SUBDIVISION REVIEW SHEET**CASE NO.:** C8-2021-0152.2A**COMMISSION DATE:** March 28, 2023**SUBDIVISION NAME:** Pinnacle at Wildhorse Ranch Section 2**ADDRESS:** 12000 Blue Bluff Road**APPLICANT:** Texas WH200, LP (Peter Dwyer)**AGENT:** Kimley-Horn & Associates (Kevin J. Burks, P.E.)**ZONING:** Wildhorse Ranch Planned Unit Development (PUD)**NEIGHBORHOOD PLAN:** N/A**AREA:** 16.13 acres**LOTS:** 54**COUNTY:** Travis**DISTRICT:** 1**WATERSHED:** Gilleland Creek**JURISDICTION:** Full Purpose**SIDEWALKS:** Sidewalks will be constructed along both sides of the internal street.**VARIANCE:** N/A**DEPARTMENT COMMENTS:**

38 C8-2021-0152.2A - Pinnacle at Wildhorse Ranch Section 2; District 1
CITY OF AUSTIN –DEVELOPMENT SERVICES DEPARTMENT
SUBDIVISION APPLICATION – MASTER COMMENT REPORT

PROJECT NAME: Pinnacle at Wildhorse Ranch Section 2
LOCATION: 12000 BLUE BLUFF RD

SUBMITTAL DATE: February 27, 2023
FINAL REPORT DATE: March 22, 2023

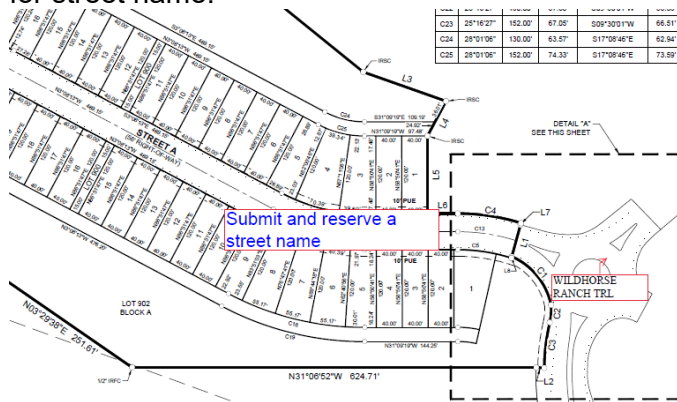
AD2: Reserve a street name labeled Street A and resubmit. Also, look at the approved preliminary plan for street name.

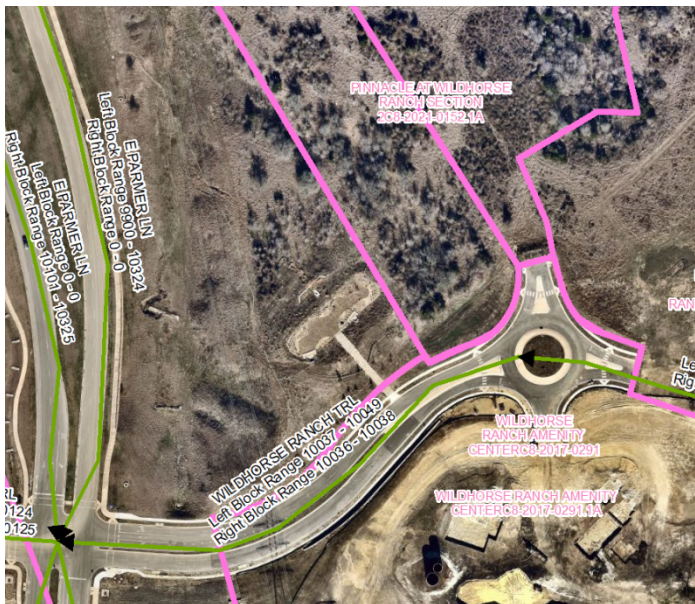
AD3: Since the **WILDHORSE RANCH TRL** deemed dedicated by way of their presence on City-owned property, the labels for these streets should be included on your plan in the vicinity map and exhibit. Please only include the built portion in the vicinity map

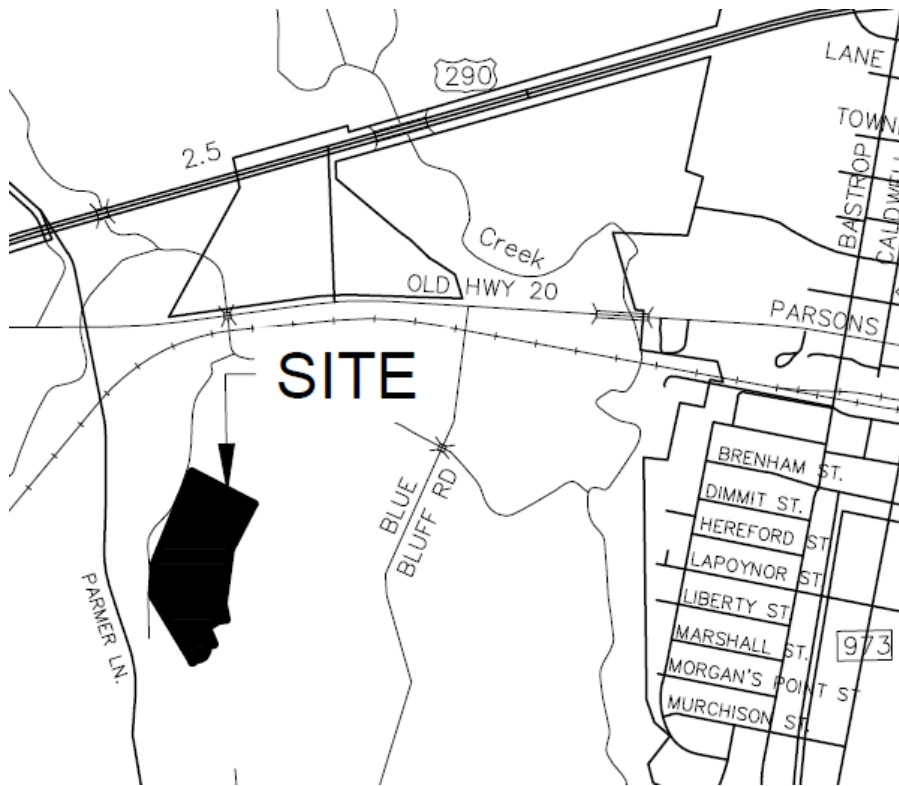
AD5: Please remove all the streets from the vicinity map EXCEPT the following:

1. Please update label for **E PARMER LN** the directional E must be included
2. Please update label for **E US 290 HWY** the directional E must be included
3. Please update label for **BRENHAM ST**

4. Please update label for **N FM 973 RD** the directional N and the street type RD must be included
